ADDENDUM 3

DATE: November 18, 2016
PROJECT: MSB First Floor Infill LRC 3 & 4
RFP NO: 744-R1705
OWNER: The University of Texas Health Science Center at Houston
TO: Prospective Proposers

This Addendum forms part of and modifies Proposal Documents dated, October 19, 2016, with amendments and additions noted below.

Reflected Ceiling Plans - Level 1

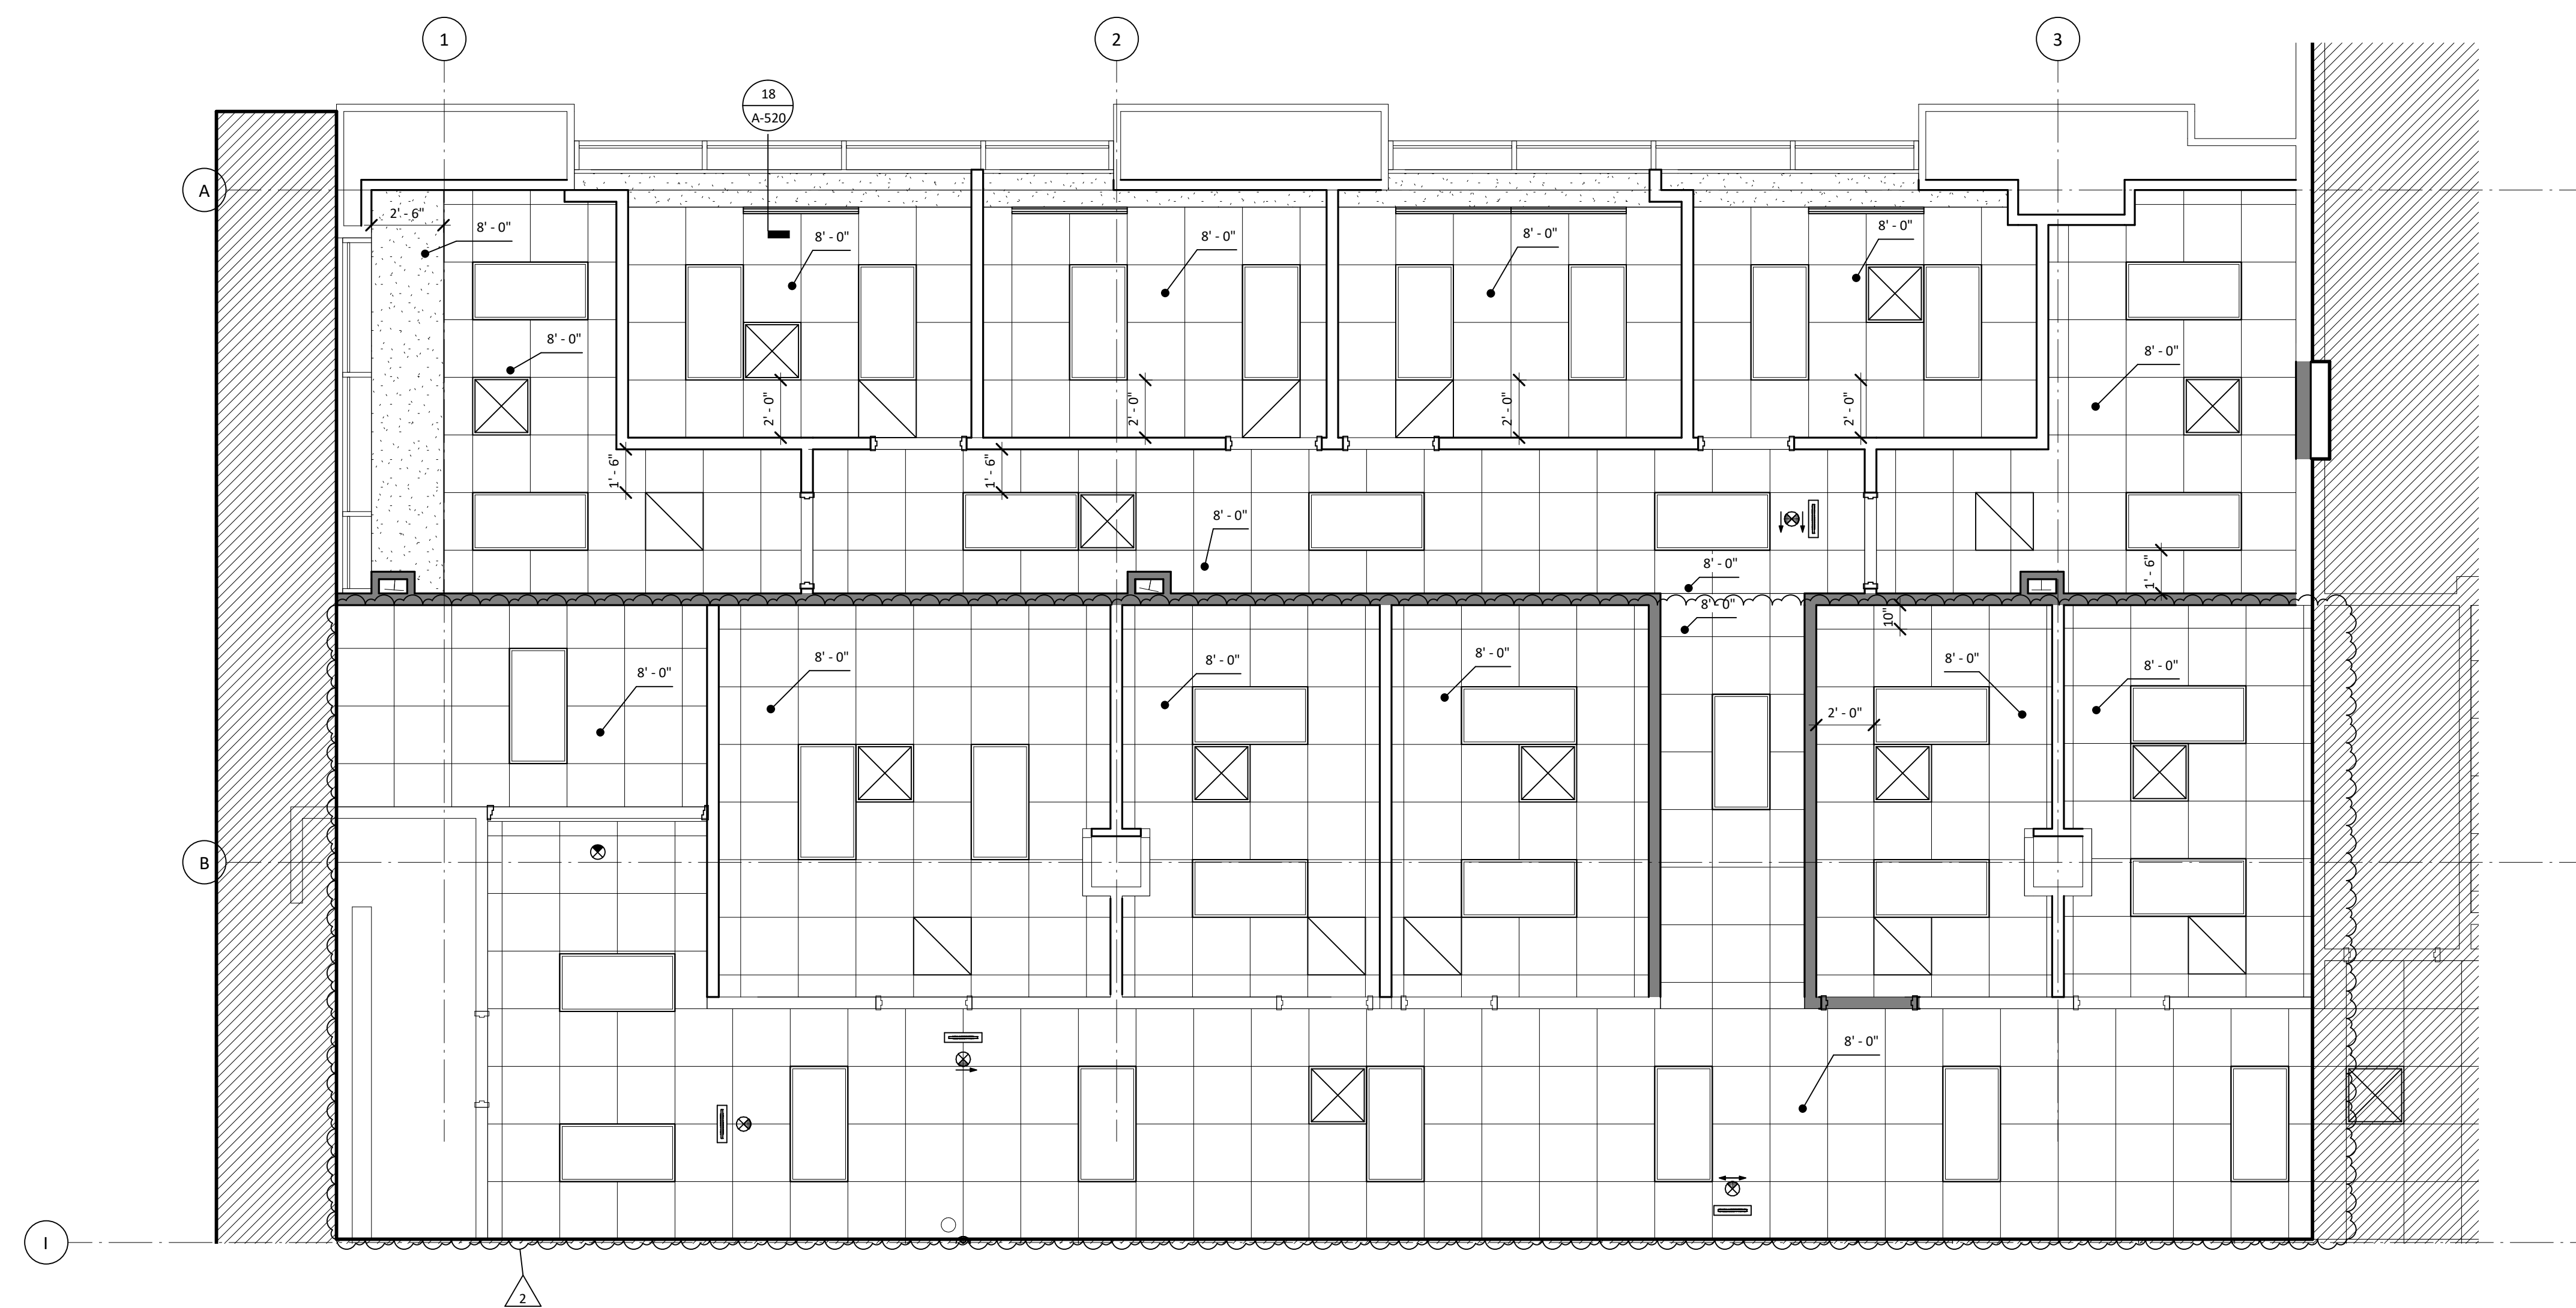
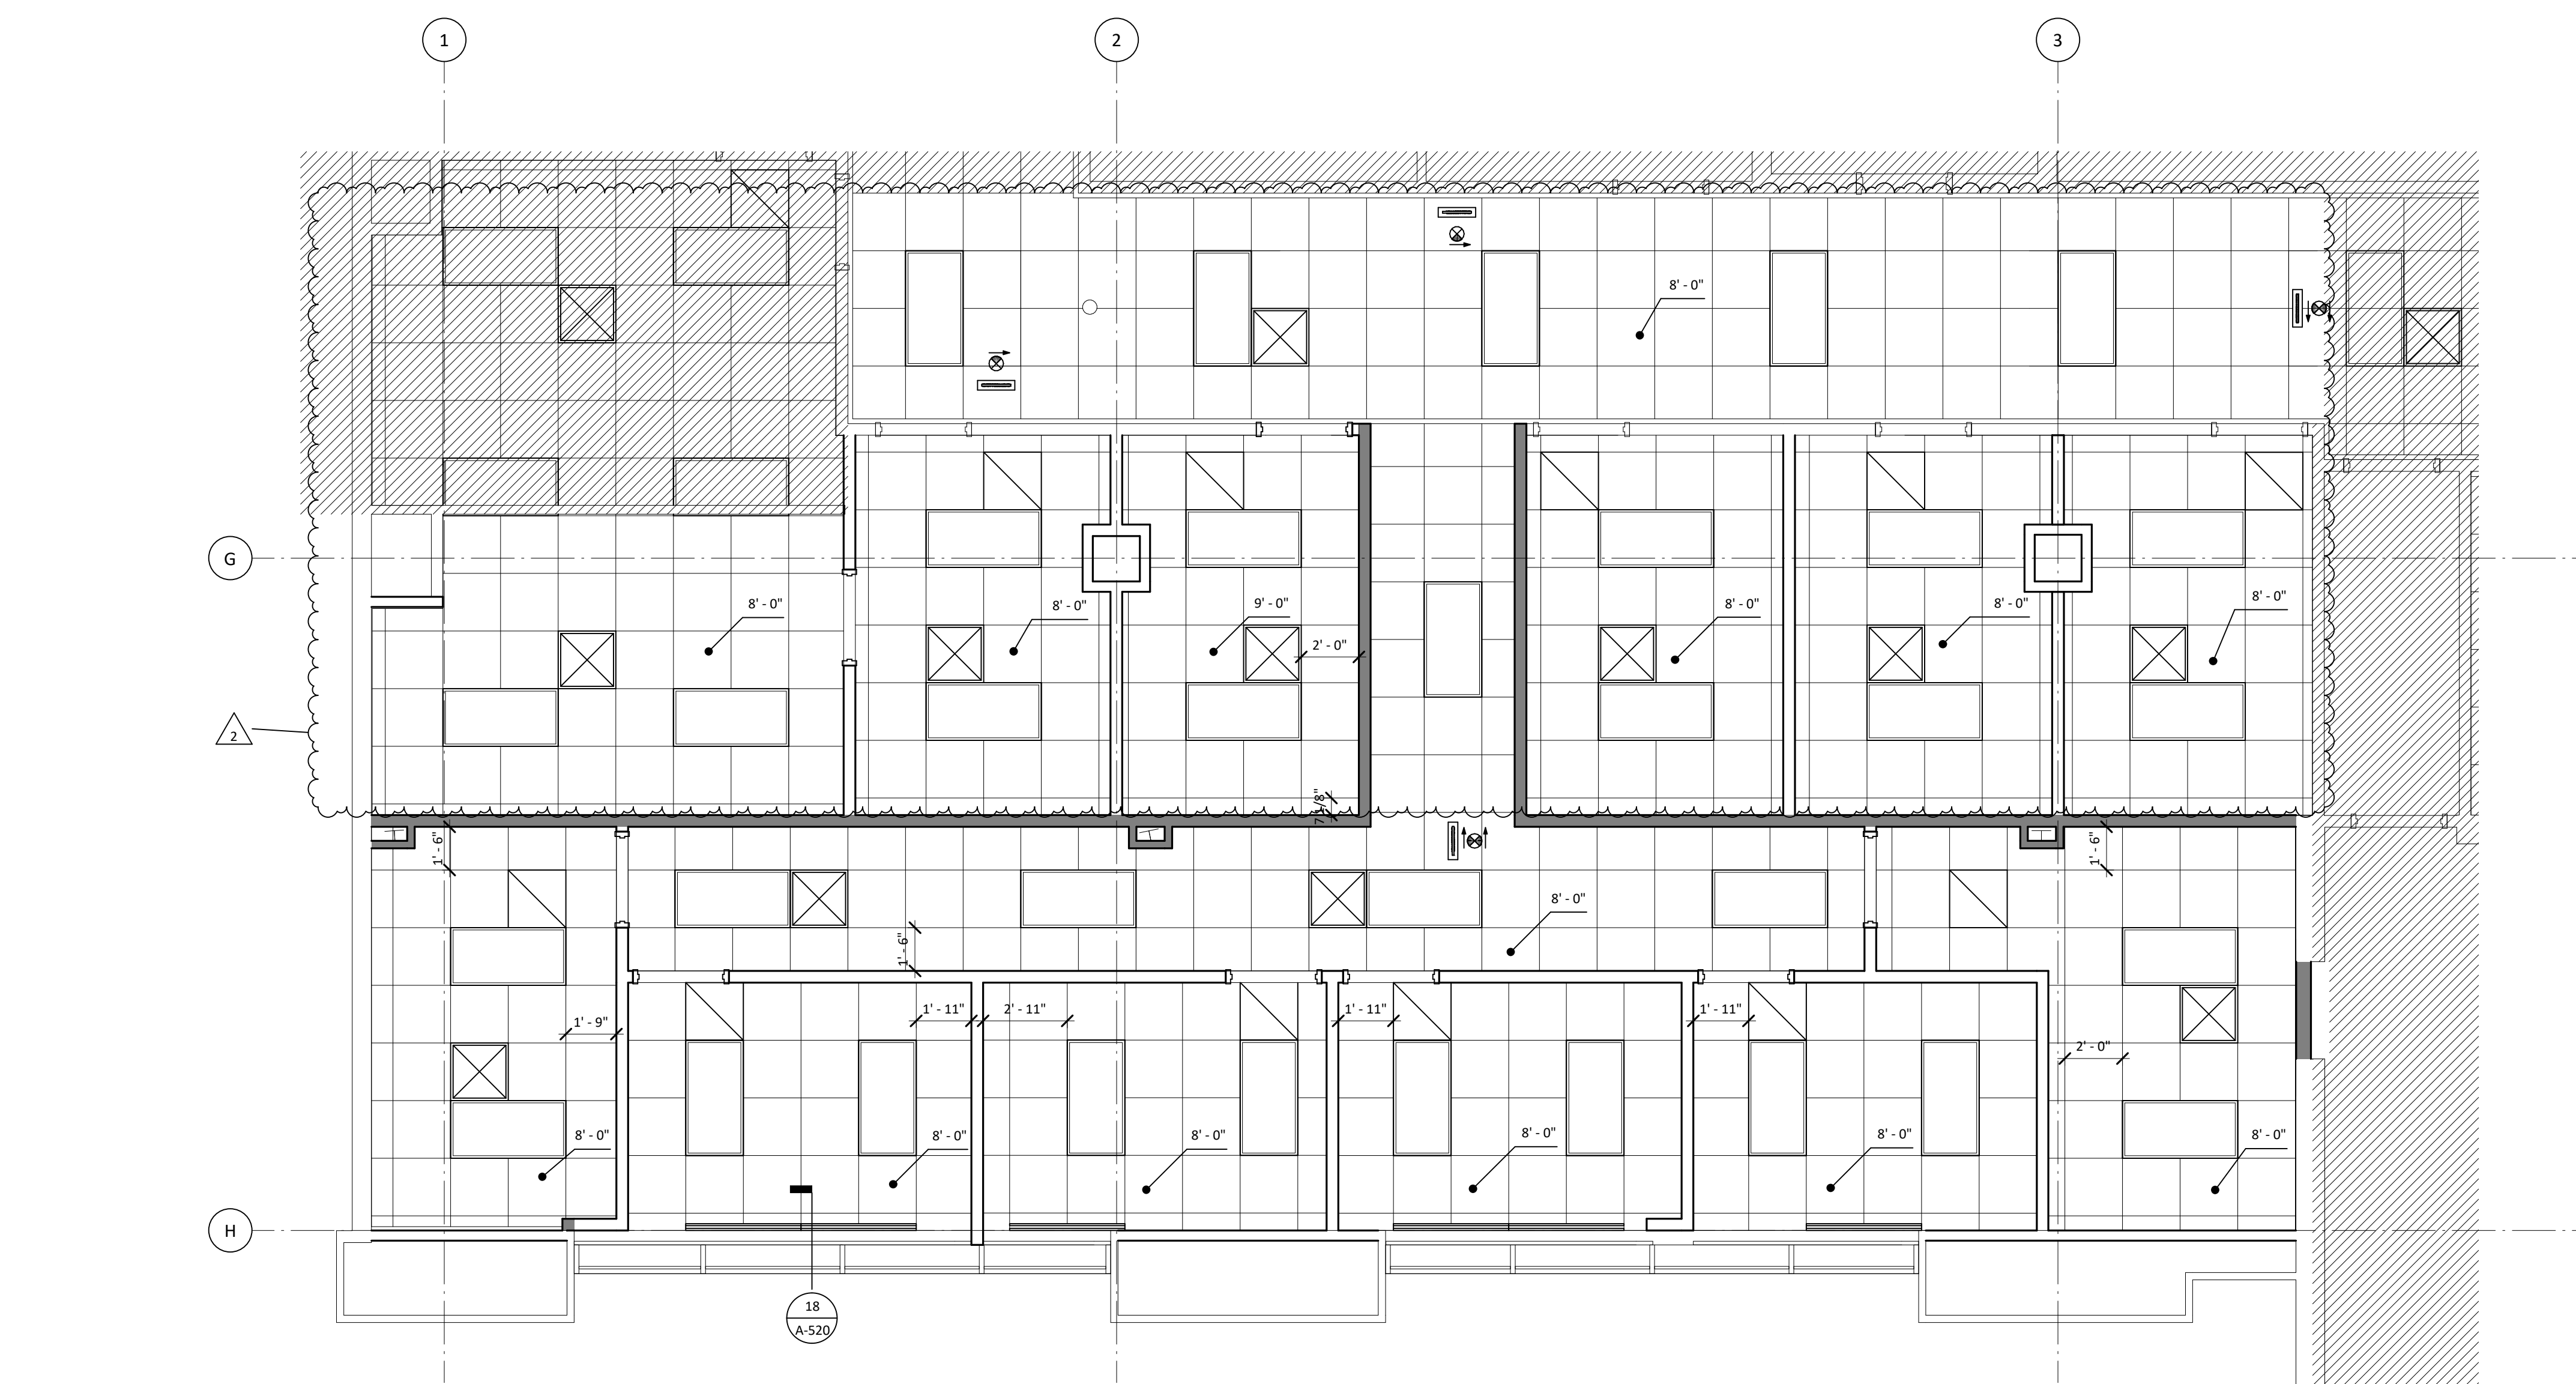
22. On drawing A-161 - Reflected Ceiling Plans Level 1, does not indicate the need for furr downs for the beams that will be installed. Ceiling grid is shown to be installed at 9'. Please confirm that the beams will be below that elevation.

Ceiling will be 8'
